2150 LAKE SHORE
BOULEVARD – STREET 'A'
MUNICIPAL CLASS
ENVIRONMENTAL ASSESSMENT

CONSULTATION RECORD
PHASE 3A

August 2023
23224

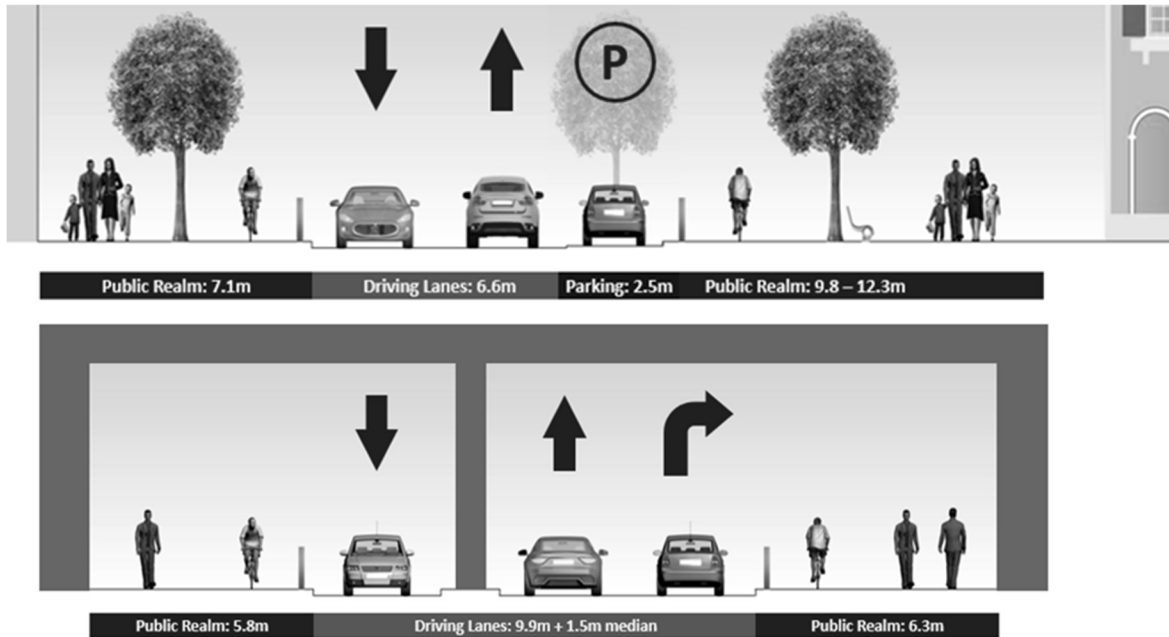
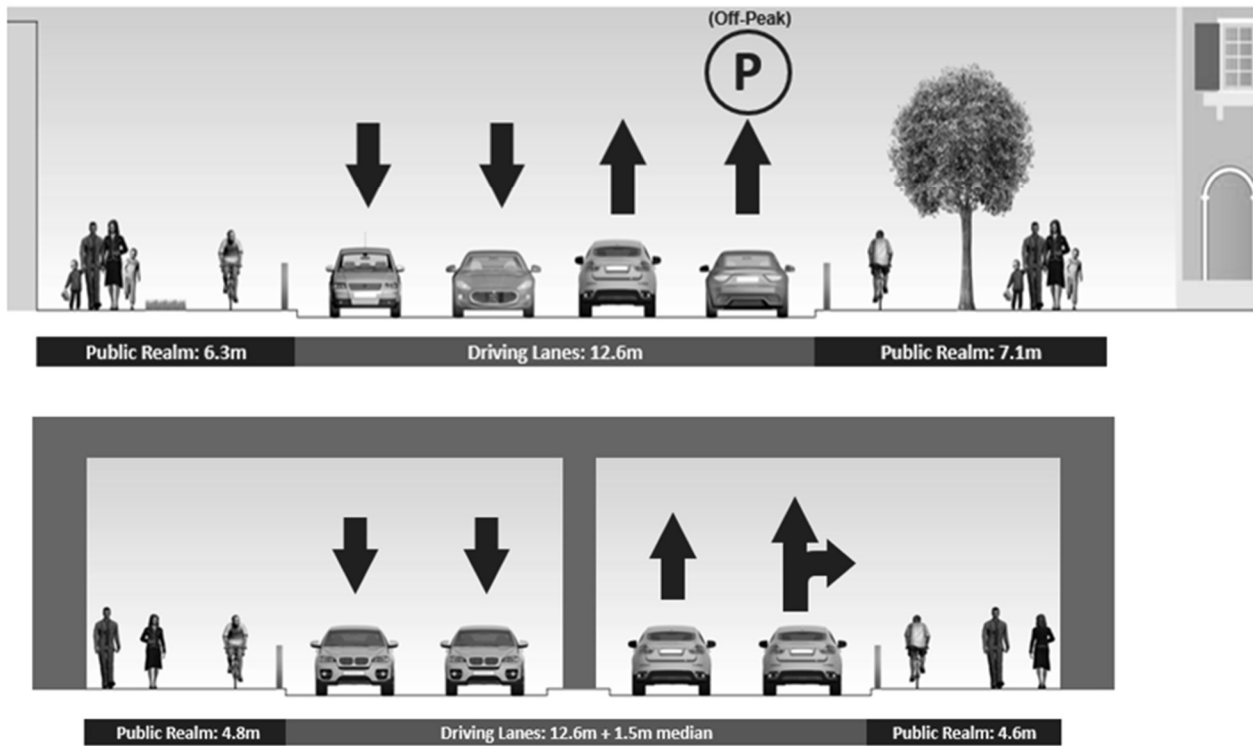
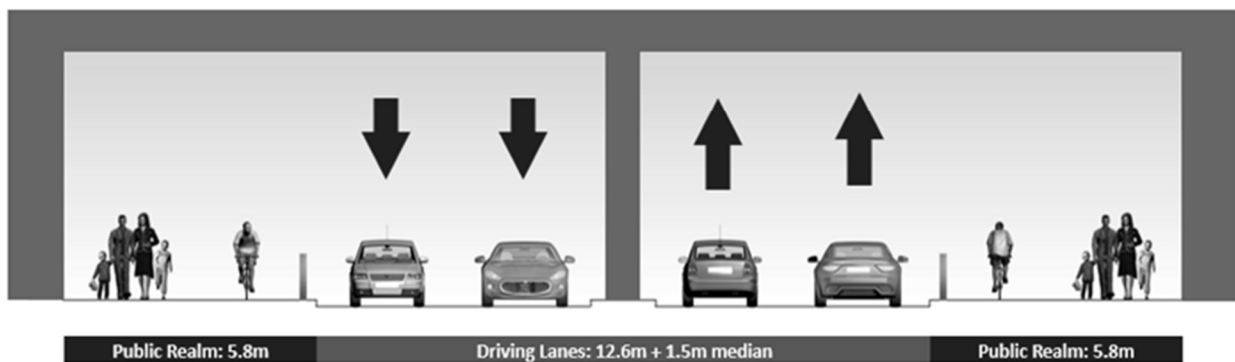
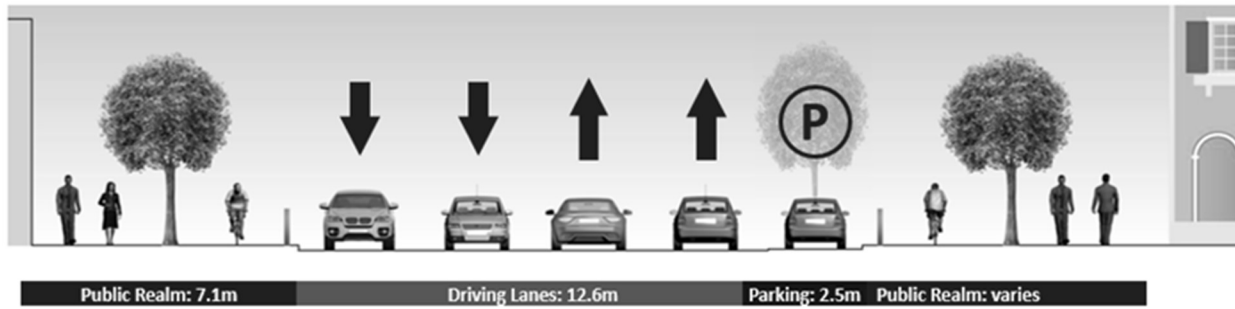
Comments Received	Project Team Response / Action
What do you like/dislike Alternative 2?	
<ul style="list-style-type: none"> Many (14) comments were supportive of 4 traffic lanes, however some (4) comments preferred 2 lanes only in order to discourage traffic/speeding. A few (2) comments mentioned safety concerns for pedestrians, cyclists and in general due to the car-oriented design of Alternative 2. Some commenters disliked Alternative 2 due to the limited pedestrian space. In terms of parking, one comment indicated more on-street parking was needed around (specifically around schools), one indicated that the proposed parking was sufficient, and three others indicated that there should be no on-street parking at all. One comment indicated that trees and green infrastructure will not survive well in a vehicle-dense corridor so they do not need to be prioritized. Therefore Alternative 2 would be preferred. However, other (4) comments indicated that Alternative 2 does not provide enough space for green infrastructure/trees. 	<ul style="list-style-type: none"> Noted that Alternative 2 may require additional mitigation measures to ensure vulnerable road users have a safe and attractive environment.

Comments Received	Project Team Response / Action
What do you like/dislike Alternative 3	
<ul style="list-style-type: none"> Alternative 3 was either very well liked or very disliked. With the increased width, several comments (7) said it would be way too busy for a residential area with concerns about safety, speeding and induced traffic demand. Other (5) comments indicated that 4 lanes would be necessary to address traffic concerns. Some (3) comments indicated that Alternative 3 was “perfect” or the “best” Some (3) comments indicated that Alternative 3 provides balanced infrastructure for all modes. Some (2) commenters would no on-street parking Some (2) comments appreciated the amount of green area in Alternative 3 One comment indicated that Alternative 3 combines the advantages of Alternatives 1 and 2 Two comments expressed concerns about cost and footprint of Alternative 3 	<ul style="list-style-type: none"> Noted that Alternative 3 may require additional mitigation measures to ensure vulnerable road users have a safe and attractive environment, and that the wide ROW doesn't induce traffic demand or encourage speeding.
